RE: Revised Remedial Design

4191 First Street, Pleasanton, California
Fuel Leak Case No.: RO0000361

Revised Remedial Design

Unocal Site 7376
4191 First Street
Pleasanton California
Alameda County Fuel Leak Case No. RO0000361

76 SERVICE STATION NO. 2707376 • 4191 FIRST STREET PLEASANTON, CALIFORNIA
 CONSTRUCTION DOCUMENTS
SITE MAP WITH PROPOSED WELL LOCATIONS
 GENERAL

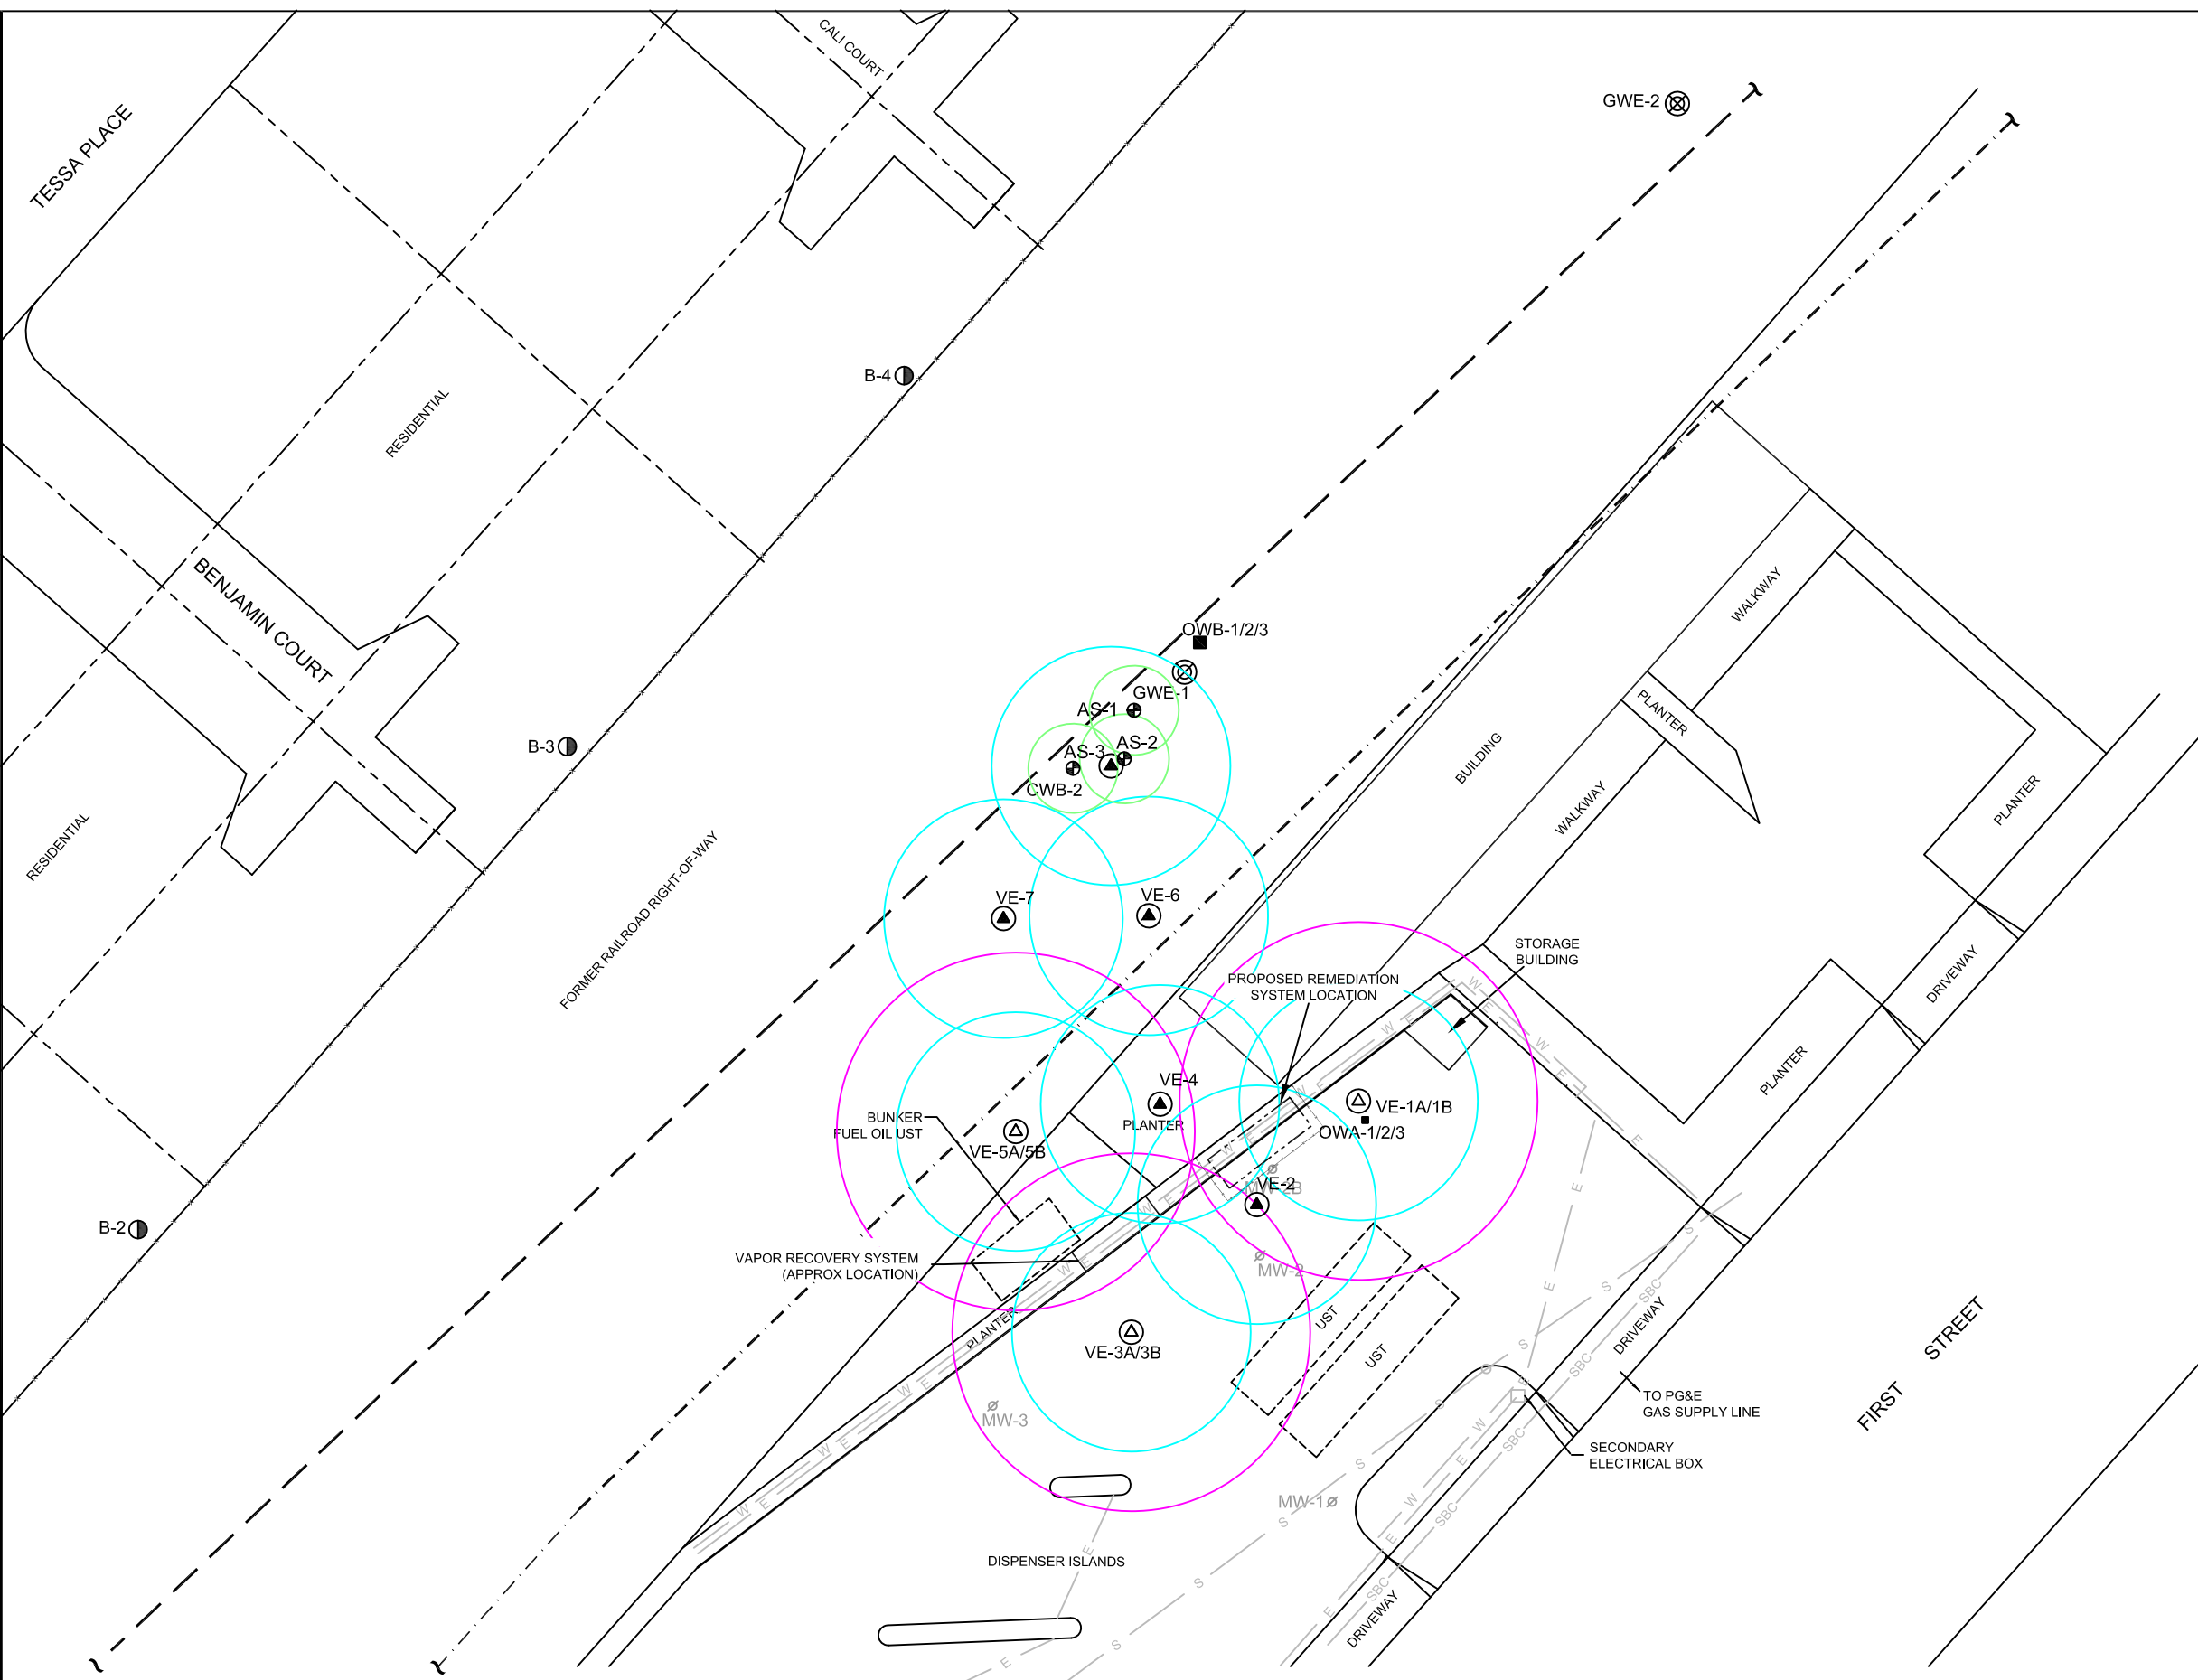
Utilizing the revised ROI, the SVE well field layout was amended resulting in a reduction of SVE wells from 29 to 11 (3 shallow SVE wells and 8 deep wells). The revised well field layout including projected ROI is presented as Figure 1.

Lithology at this site appears conducive to AS. AS has a higher probability of success at addressing dissolved phase impacts in proximity to MW-5. Therefore, ARCADIS is proposing the incorporation of three AS wells into the system. Conservatively, a 10 foot ROI for AS was assumed. The screen interval is proposed to be 80 to 82 feet bgs but will be modified if fine grained sediments are encountered at a shallower depth. The AS well field layout including projected ROI is shown on Figure 1.

Graphical ROI Determination

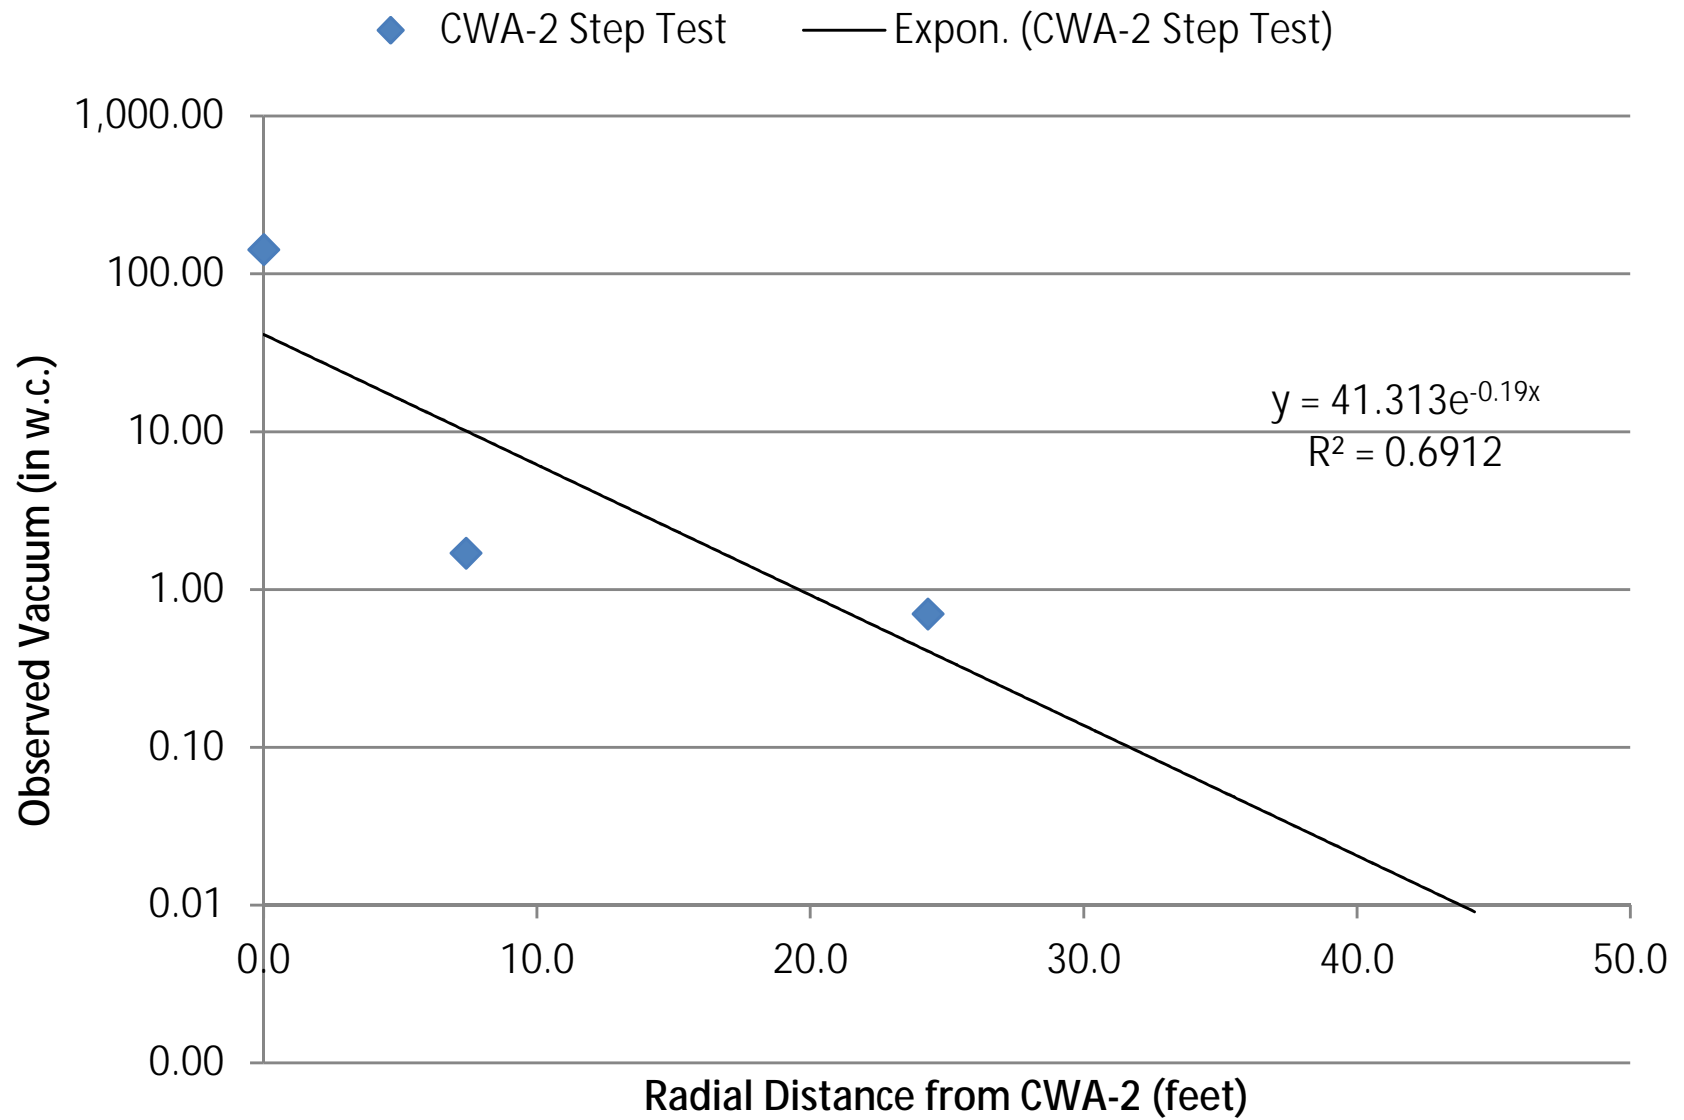
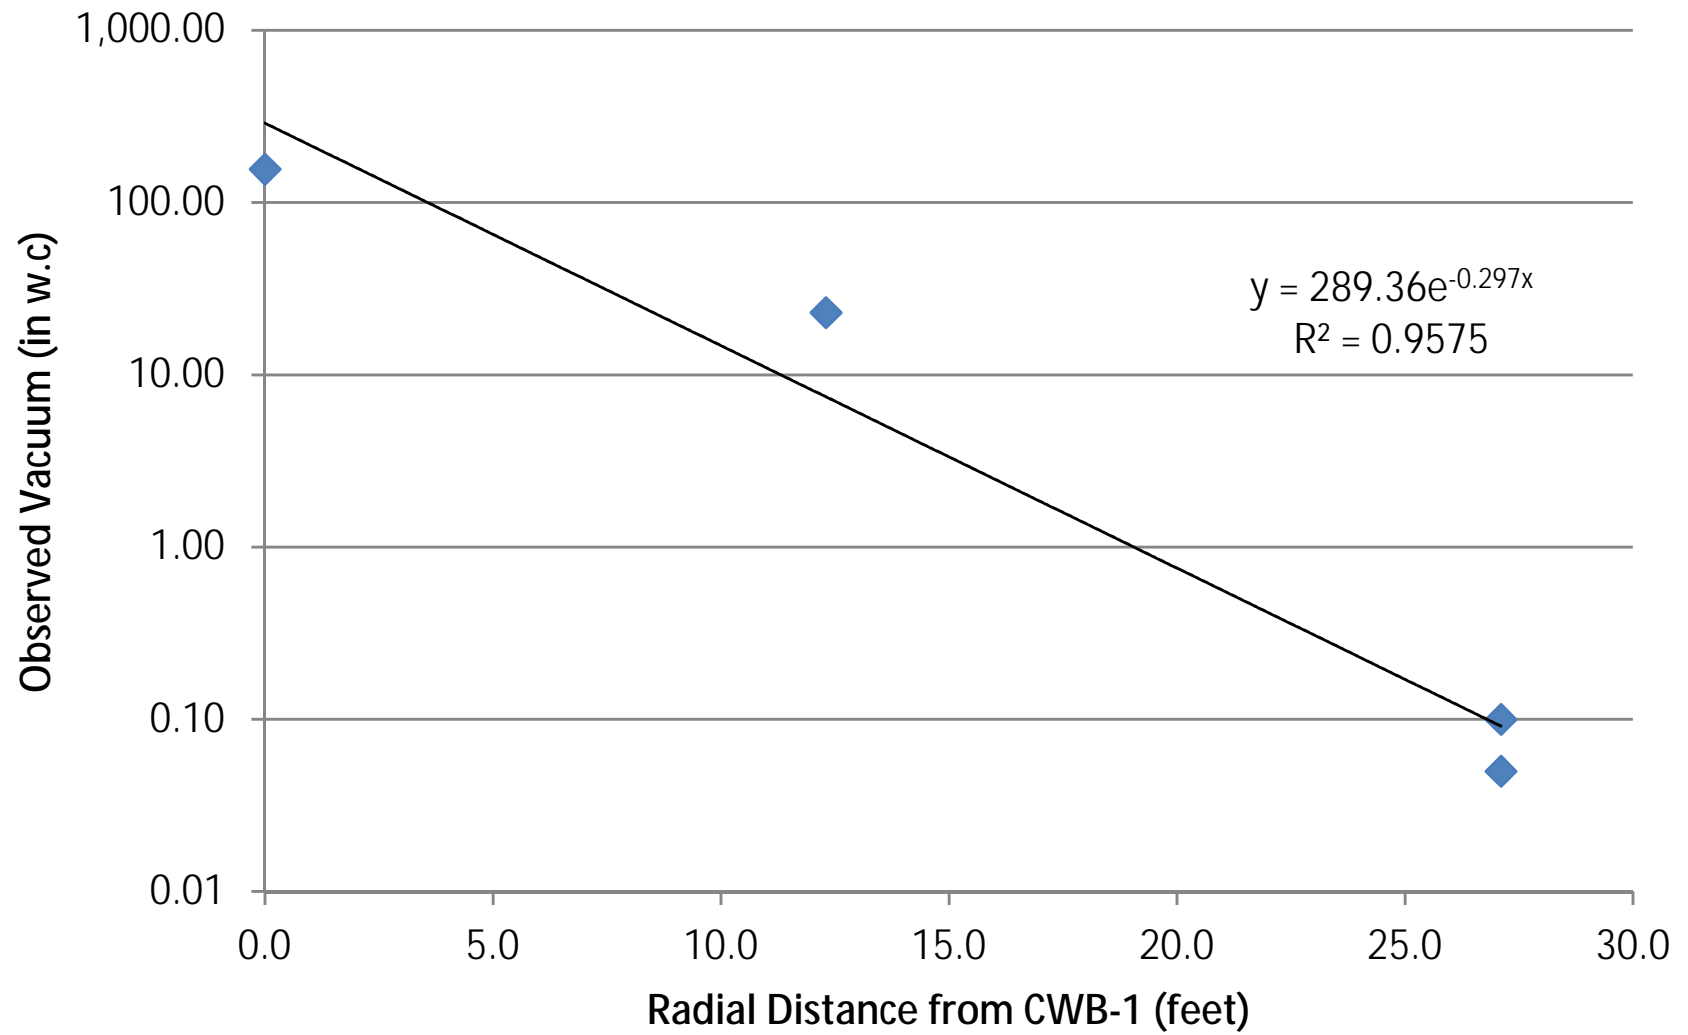
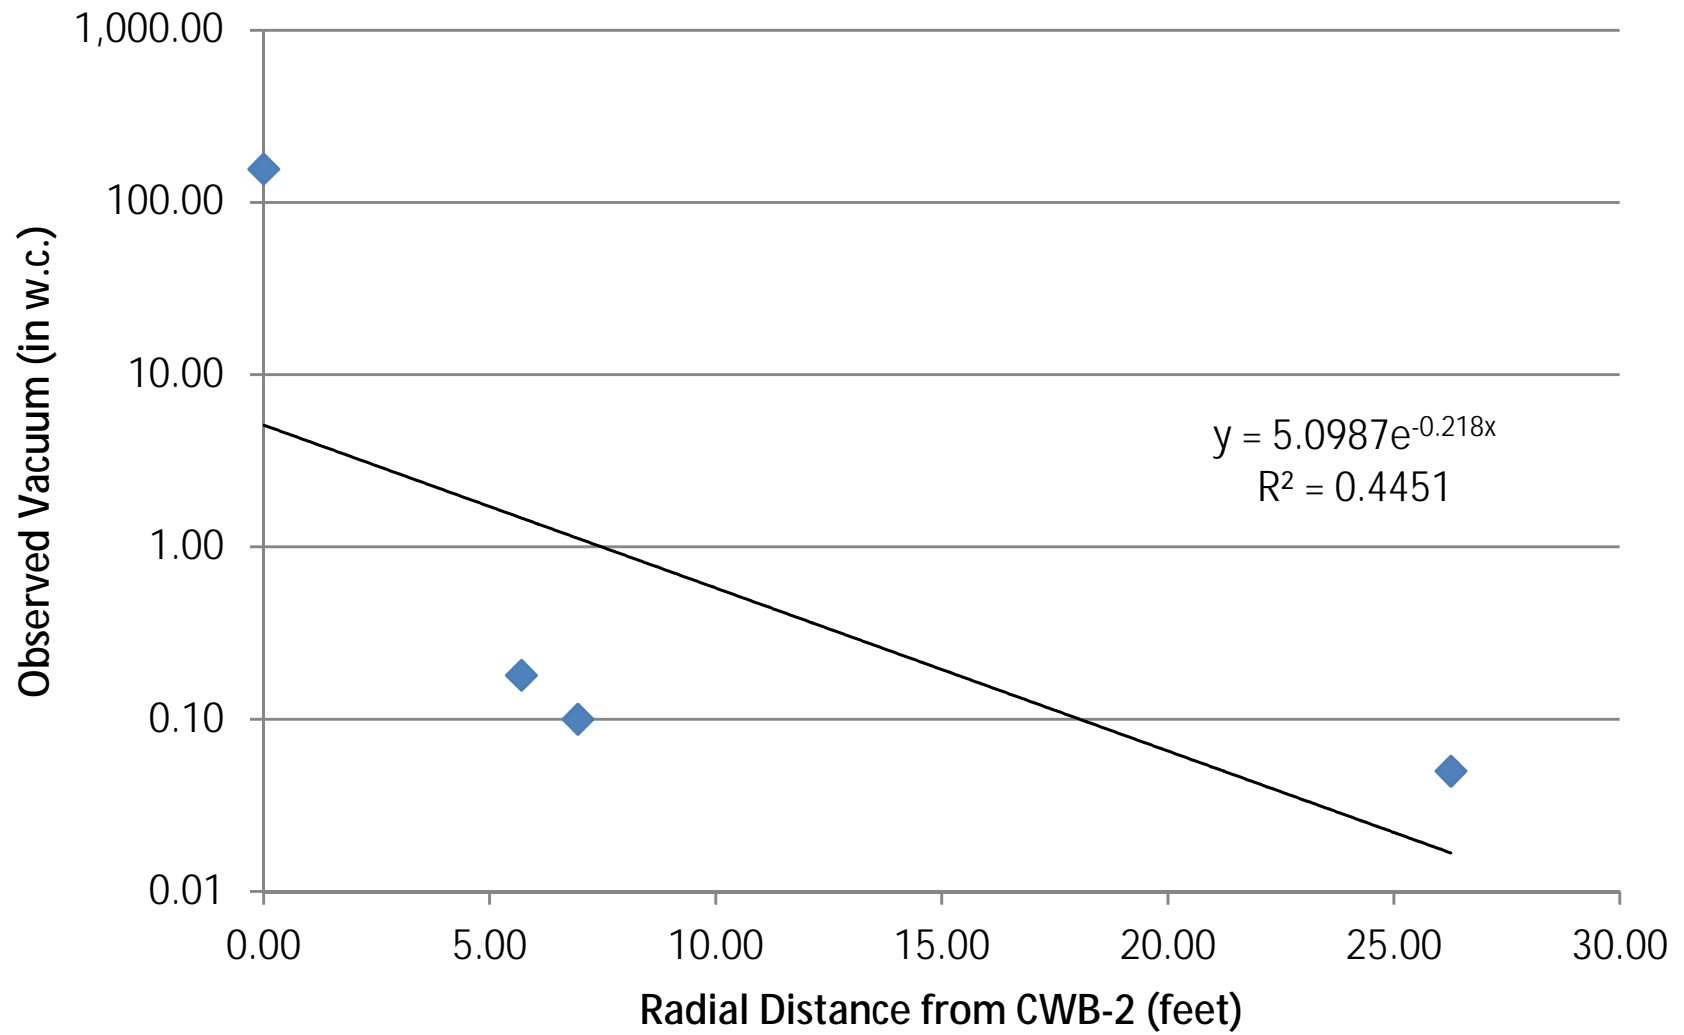
Graphical representation of ROI is typically presented on a log normal basis. The ROI as presented in the Revised RAP had both the vacuum and distance in a normal scale which resulted in a ROI of 12 feet. As a result the ROI presented with the Revised RAP underestimates the influence of both the shallow and deep SVE wells.

ARCADIS recalculated the ROI using results from observation wells with screen intervals similar to the SVE well. The ROI was based on a curve fit of observed wellhead vacuums measured at the observation wells versus radial distance from the SVE well. The ROI is defined as the radial distance from the wellhead where 0.1 inches of water column (in. W.C.) would be observed. SVE ROIs for shallow wells ranged from 31 to 54 feet. Conservatively a log average ROI of 30 feet was used for design purposes. SVE ROIs for deep wells ranged from 18 to 27 feet.

Conservatively a log average ROI of 20 feet was used for design purposes. The revised design ROI for the shallower zone (sands/gravels) and deeper zone (finer grained soil) is 30 feet and 20 feet, respectively. Revised graphical ROI determinations for shallow and deep wells are presented with Attachment 1.
